February 21, 2024

Subject: PA-2022-099 1855 S. Norfolk St., SUP + SPAR + SDPA
1885 S. Norfolk St., APN 035-383-200

Planning Comments:**1. Planning Application Guide Submittal Requirements**

Both Buildings Combined

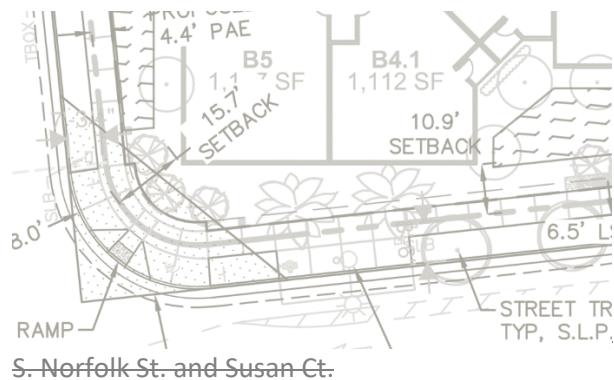
- Please update this information based on the comments for the individual buildings.

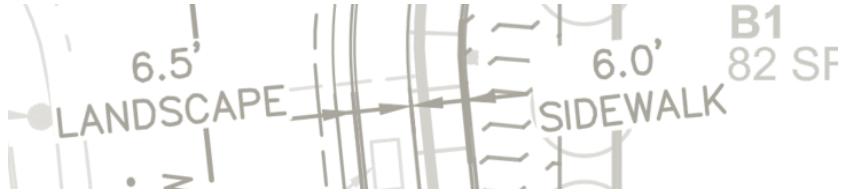
- Please update the arrows provided for the 4.5ft. landscape strip and the 5ft. sidewalk shown along S. Norfolk St. and Susan Ct. Currently it is not clear where each begins and ends since the arrows seem to overlap.

- **Cycle 2** – Comment still stands. The arrows provided below still conflict with each other.

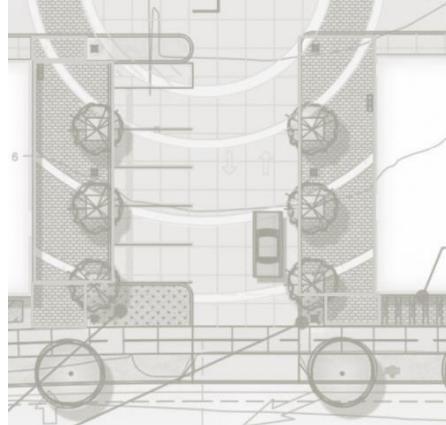
- Please label and dimension the paved walkways on each side of the driveway.
 - **Cycle 2** – Comment still stands. Please provide the dimensions of the accent vehicle/ pedestrian paving on both sides of the uncovered parking.

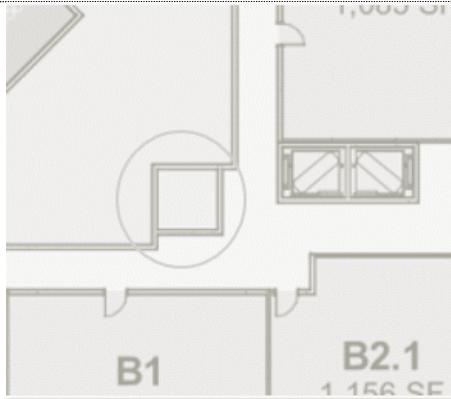
<p><input type="checkbox"/> FLOOR PLANS (1/4" scale preferred). Drawn to scale and showing the following:</p> <ul style="list-style-type: none"> • Proposed floor plans. <ul style="list-style-type: none"> ○ Please provide a legend that corresponds to the colors on the floor plans to identify the proposed use for each space. • Overall exterior dimensions and individual room dimensions for all levels and stories. <ul style="list-style-type: none"> ○ Please provide overall exterior dimensions of all floors. ○ Please provide enlarged unit plans for each plan type. <ul style="list-style-type: none"> ▪ Cycle 2 – There are only 5 unit plans shown on sheet AP4.00; however, 13 unit types are listed in the project information tables on sheet AP0.00. Please provide unit plans for each type of unit. <ul style="list-style-type: none"> • Cycle 3 – Floor plans for all units must be included in the plans before they can be deemed complete. ▪ Cycle 2 – Please provide typical room dimensions on unit plans. • Cycle 4 – Please provide floor plans for the mechanical rooms, bike and watersport room, co-work room, lobby and mail/parcel area, the lobby and leasing area, and the fitness and lounge area on the second floor of the North building. These floor plans must be provided in the final version of plans. • On sheet AP0.03, please provide a breakdown of units by floor for each building. • Location of all doors and windows, including window sizes. <ul style="list-style-type: none"> ○ Please show and dimension all window and door openings on the floor plans. <ul style="list-style-type: none"> ▪ Cycle 2 – The unit plans do not show openings for windows. Please dimension and show the windows in each unit plan. The windows shall correspond with the window placement on the proposed elevations. ○ Please see the <i>Design Comments</i> section for information of natural light in the residential corridors. • Please identify the proposed use(s) that occur on the roof deck. In particular, there is an unlabeled room on the roof deck. Unless exempted by SMMC 27.02.060, rooftop uses such as storage or toilet rooms increase the plateline of the building. <ul style="list-style-type: none"> ○ Cycle 2 – Please provide a section detail of the penthouse. • Please label all rooms on the floor plan of the North Building. Please see image below.

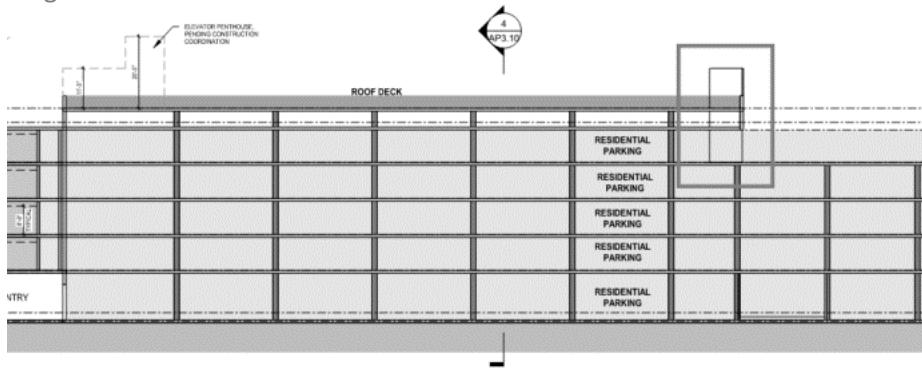
- Please provide a longitudinal and cross section for each building.
 - **Cycle 2**—The numbers on the section diagram do not match the numbered building sections on AP3.10.

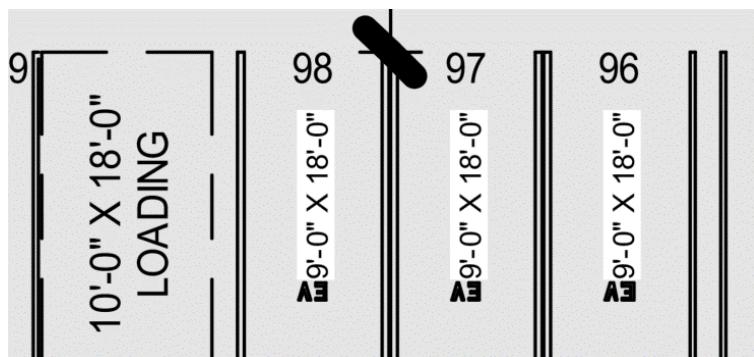
<input type="checkbox"/>	<p>PARKING LOT OR GARAGE PLANS (1/4" scale preferred). Drawn to scale and showing the following:</p> <p>Cycle 4 – (Informational) Additional comments may follow changes to site plan.</p> <ul style="list-style-type: none"> ● Summary calculations of parking required versus proposed and breakdown of type of spaces (standard, compact, accessible) per Zoning Code requirements. <ul style="list-style-type: none"> ● Please see Building Division comments #2-3 for information regarding the required EV stalls. ● Cycle 2 – Comment still stands. Please see Building Division comments #3-5 for additional information. ● Please provide a calculation table for the required retail/cafe parking on sheet AP0.03. Clarify on the plans if any other areas (workspace, boat storage) are public – this may require more parking. <ul style="list-style-type: none"> ● Cycle 2 – The unit count used for parking calculations is incorrect across the data tables. Please update these numbers and parking totals throughout the plans. ● Dimensions of all parking spaces, aisles, driveways, and turning radii of all driveways. <ul style="list-style-type: none"> ● Cycle 2 – Stalls #141, 197, 253 are standard restricted stalls and must have a width of nine feet. ● Cycle 2 – Please dimension the passenger loading zone next to all ADA spaces. ● Please see <i>Density Bonus</i> sections below for information on the loading spaces. <ul style="list-style-type: none"> ● Cycle 2 – Comment still stands. ● Please show and dimension the three foot area required at the end of dead end stalls #47 and #75. ● Additional comments may follow once information of the columns and support structures of the garage are provided. ● Designation of all parking spaces (compact, standard, accessible, visitor, tenant). <ul style="list-style-type: none"> ● Please label the four uncovered spaces and whether the spaces are designated for residential visitors or retail/café patrons. ● Cycle 2 – The required number of parking stalls is 310. A maximum of 40 % of the required stalls may be compact. The total number of compact stalls shall not exceed 124 stalls. ● All structural elements (curbs, columns, walls, or structures) which confine sides of parking stalls. <ul style="list-style-type: none"> ● Please label or provide a legend for each type of line/striping/wall depicted in the garage. Parking stall dimension may need to be modified if any structural elements are located between stalls. Please see below for an example.
